ADDENDUM NO. 4

Reference: Holland Centennial Commons
Dixie State College – St. George, Utah
DFCM Project No. 06297640

ADDENDUM No. 5

**Dixie State College of Utah
Holland Centennial Commons
Addendum #5
Civil Drawings and Specifications**

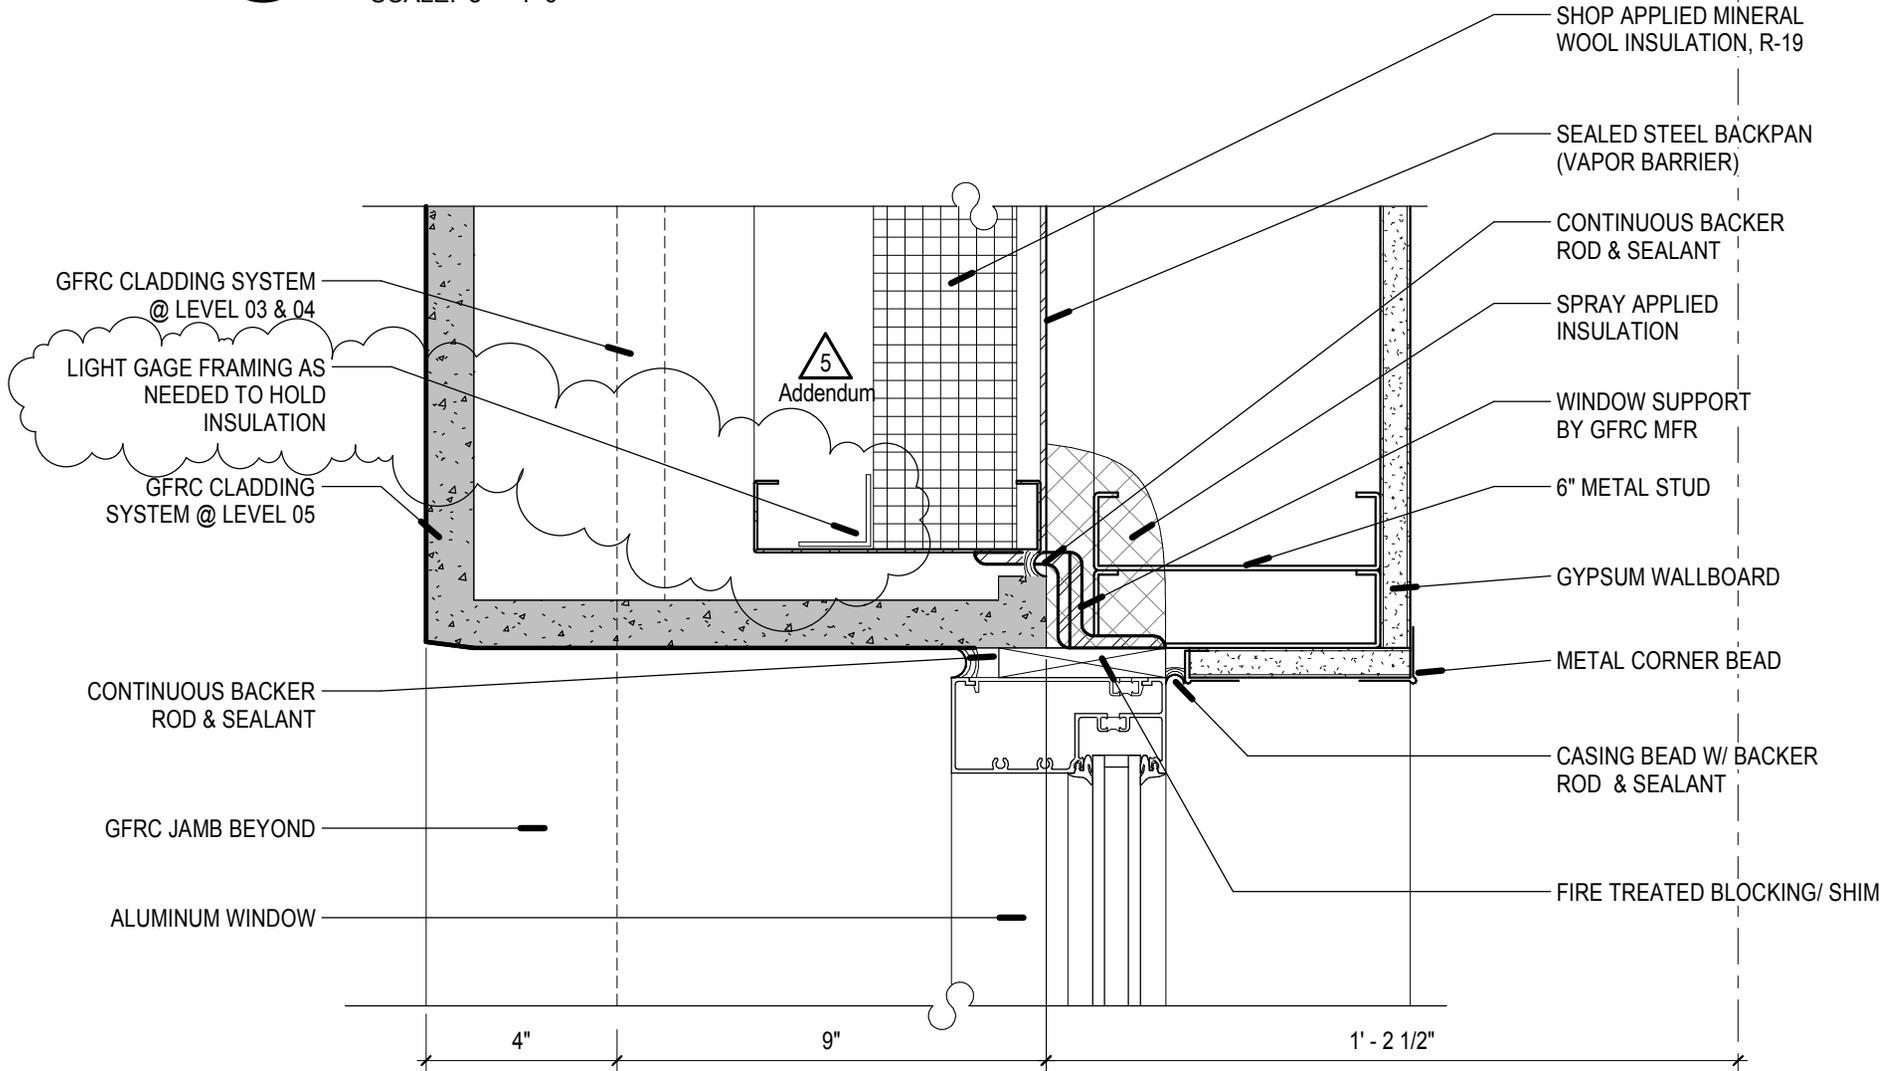
Item	Description
5.1	GFRC Details Add light gage framing where needed to securely hold the insulation in place within the GFRC panel system. Framing should be on vertical sides to allow weeping at the bottom of the panel. See attached for revised Detail B5/A513 for example.

HOLLAND CENTENNIAL COMMONS
 ADDENDUM #5
 SHEET C101

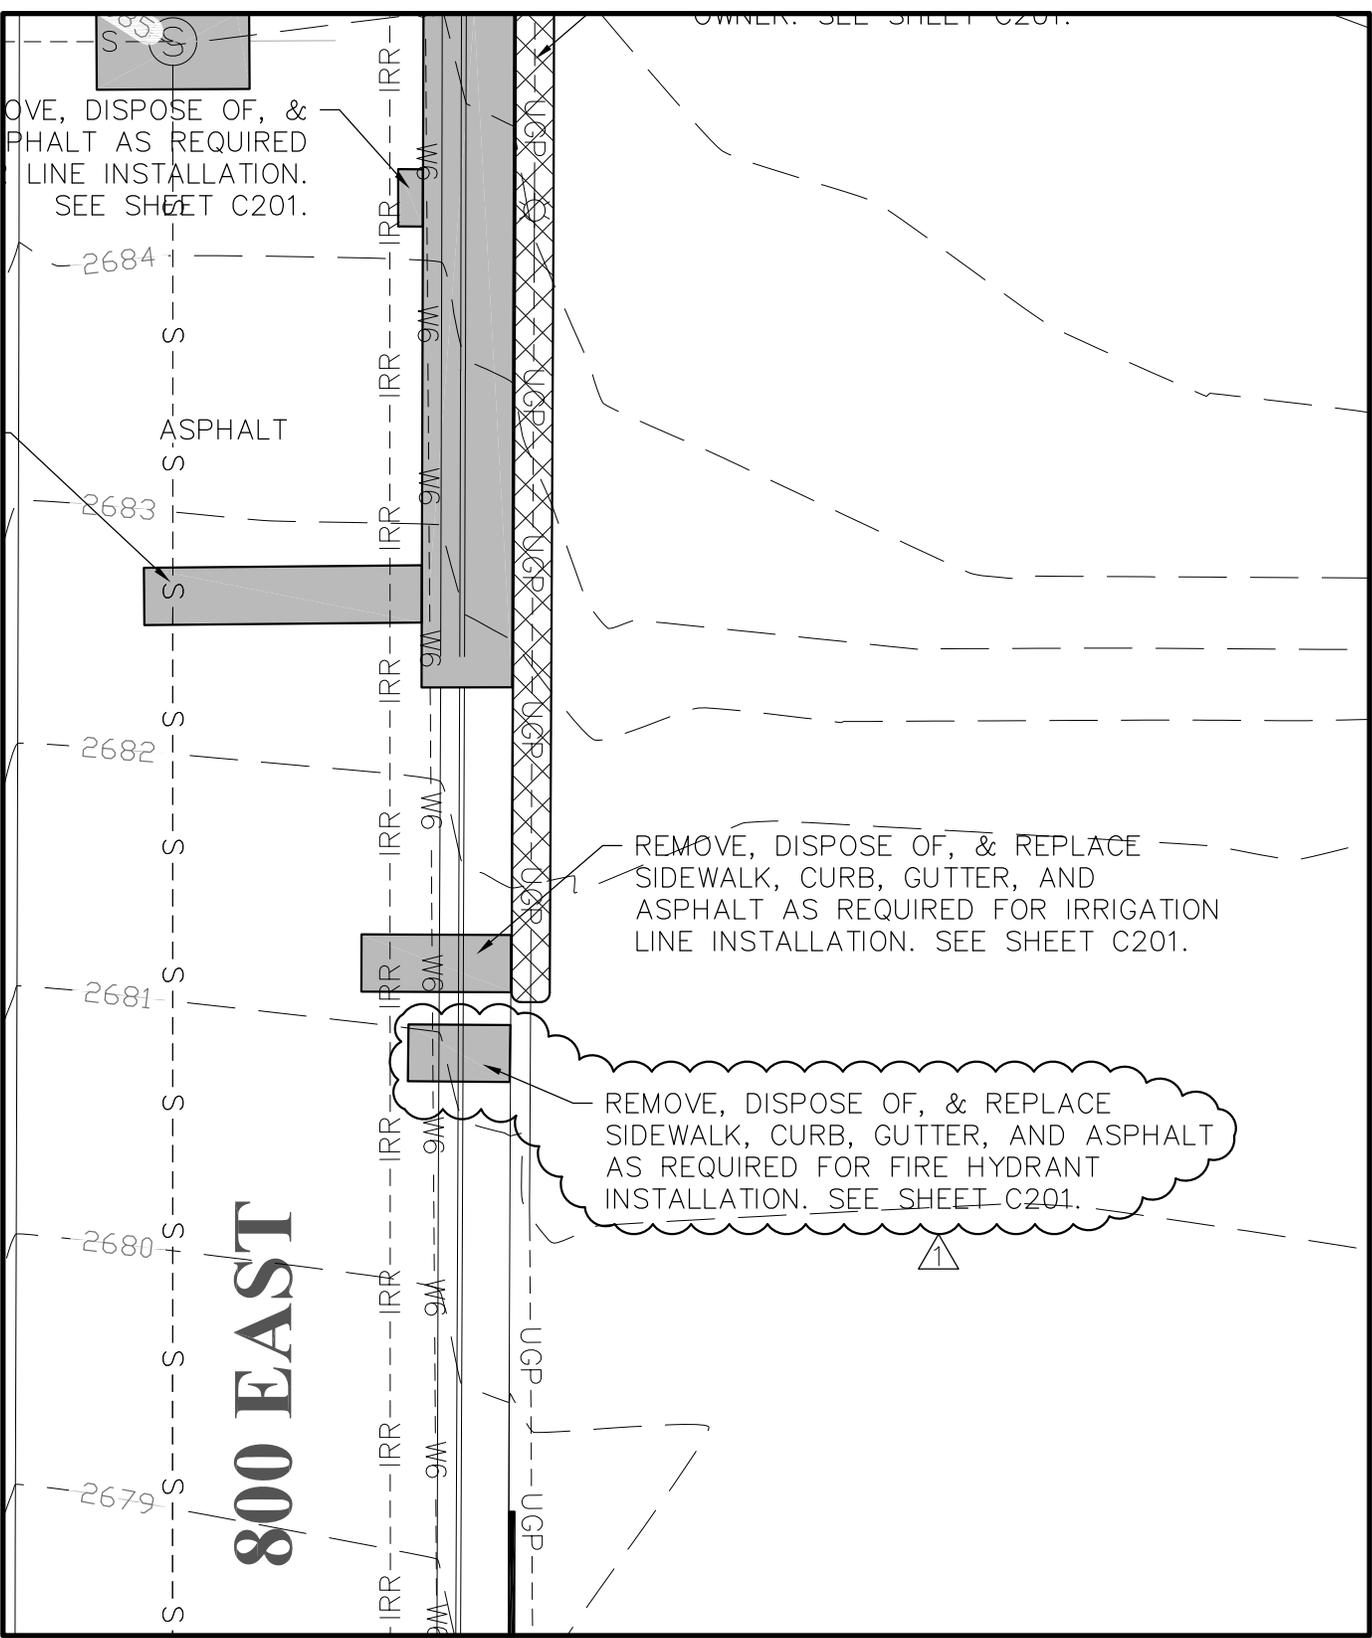
3. A note has been added to call out sidewalk and asphalt replacement for the installation of the new fire hydrant per Item #7 of this addendum. See sheets AD5-3 through AD5-5 of this addendum.

▲ ADDED ASPHALT/SIDEWALK REPLACEMENT

HOLLAND CENTENNIAL COMMONS
 ADDENDUM #5
 SHEET C201

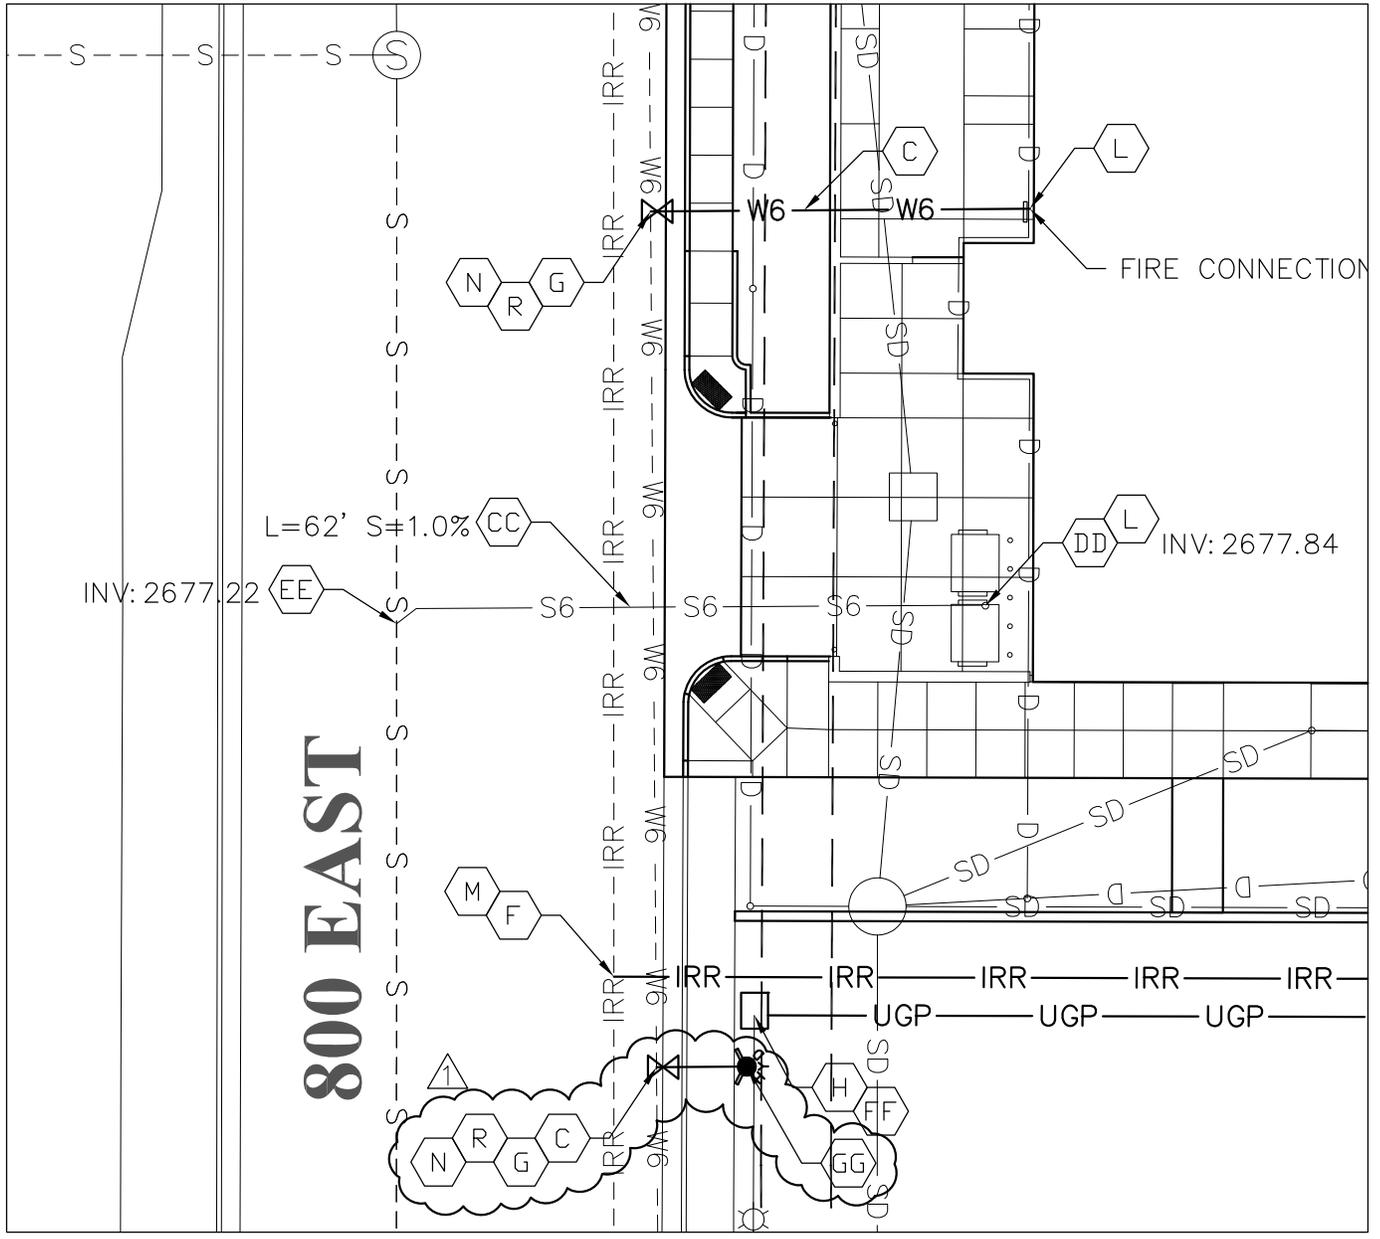
7. A new fire hydrant and connection to the existing water line along 800 East has been added. See sheets AD5-3 through AD5-5 of this addendum.

ADDED FIRE HYDRANT & CONNECTION TO EX. WATER

HOLLAND CENTENNIAL COMMONS
ADDENDUM #5
SHEET C501

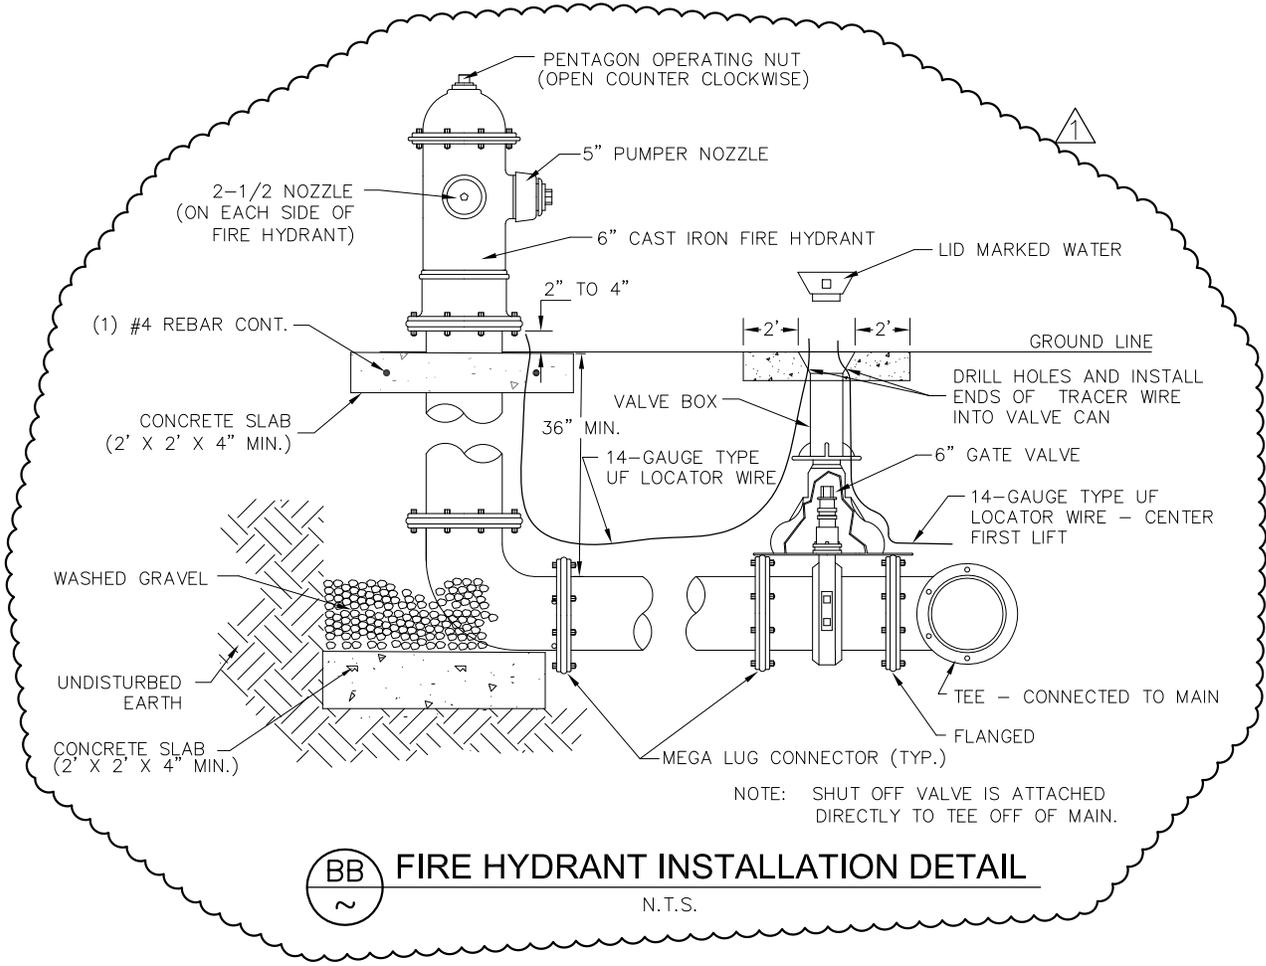
10. A detail for a fire hydrant has been added to the details per Item #7 of this addendum. See sheets AD5-3 through AD5-5 of this addendum.

▲ ADDED FIRE HYDRANT DETAIL

ADDENDUM #5
SHEET C102

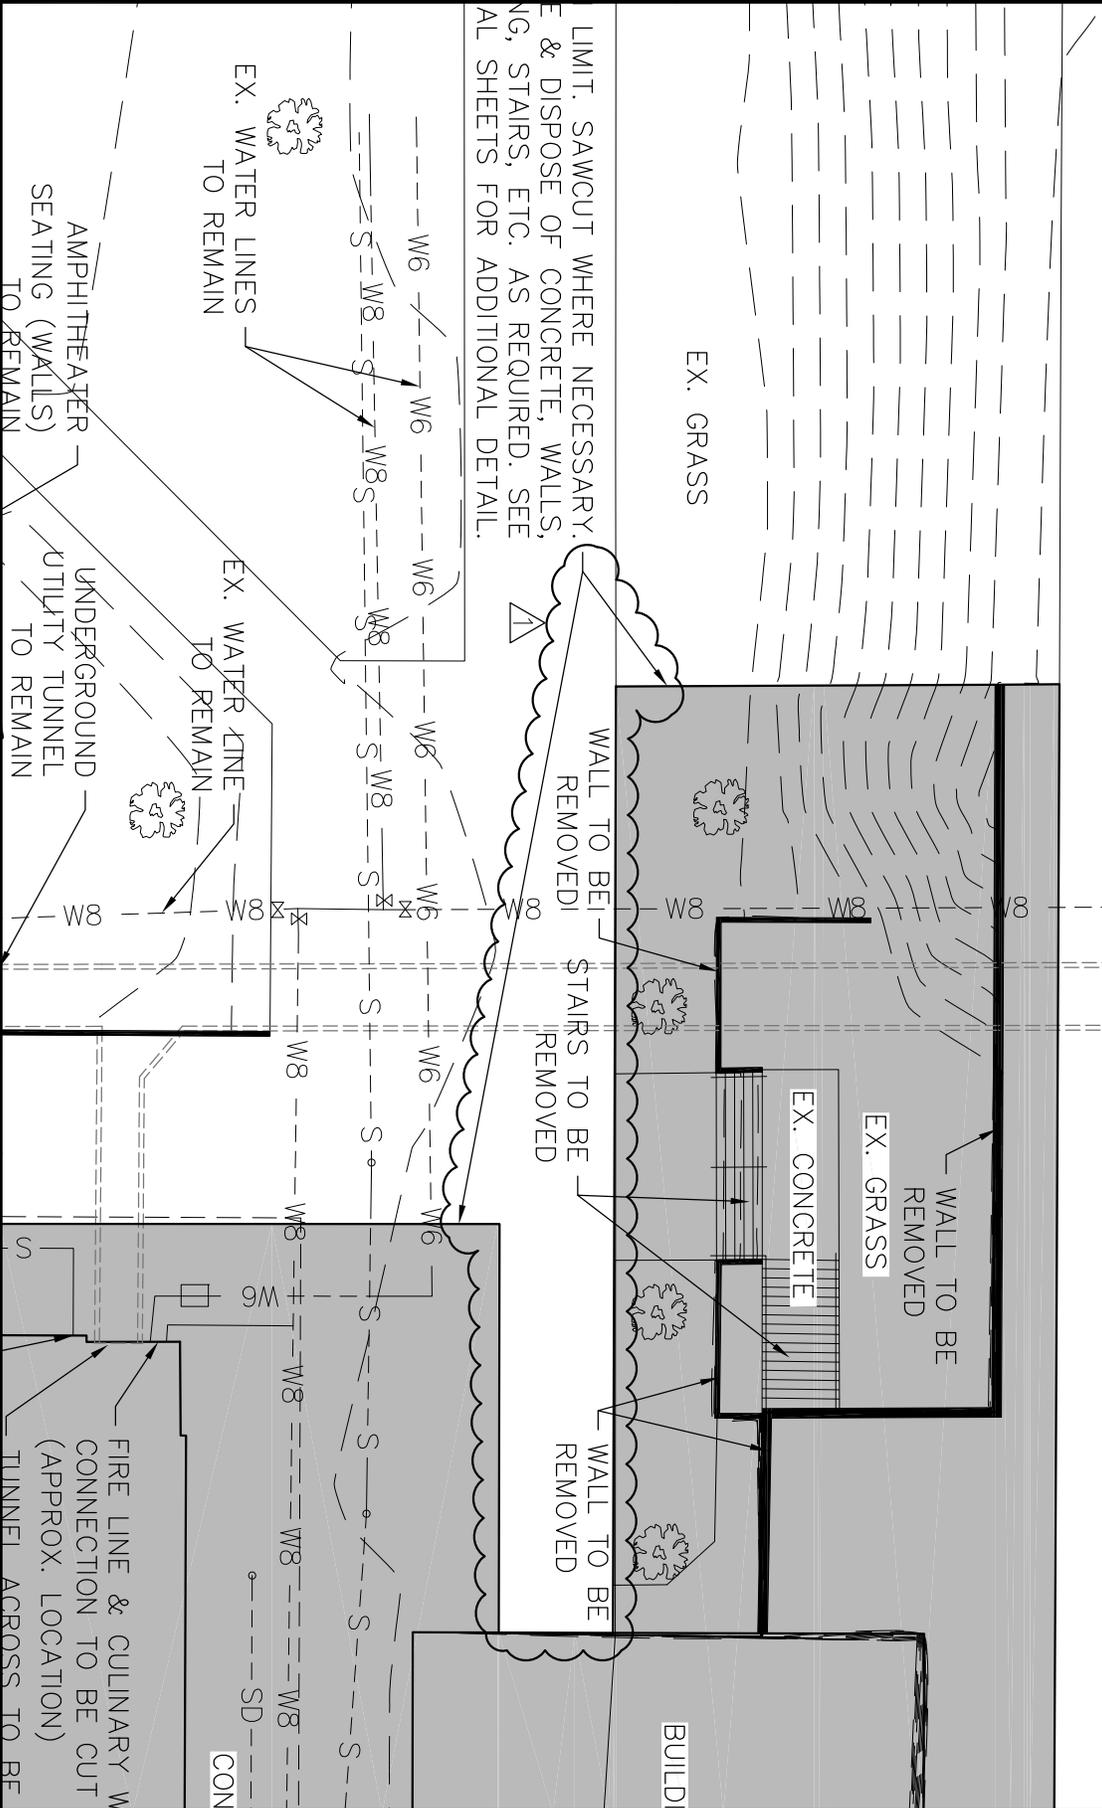
4. Demolition limits around the Whitehead Building and Career Center have been modified. See sheets AD5-6 and AD5-7 of this addendum.

AD5-6
MODIFIED DEMOLITION LIMIT & SAWCUT LINE.
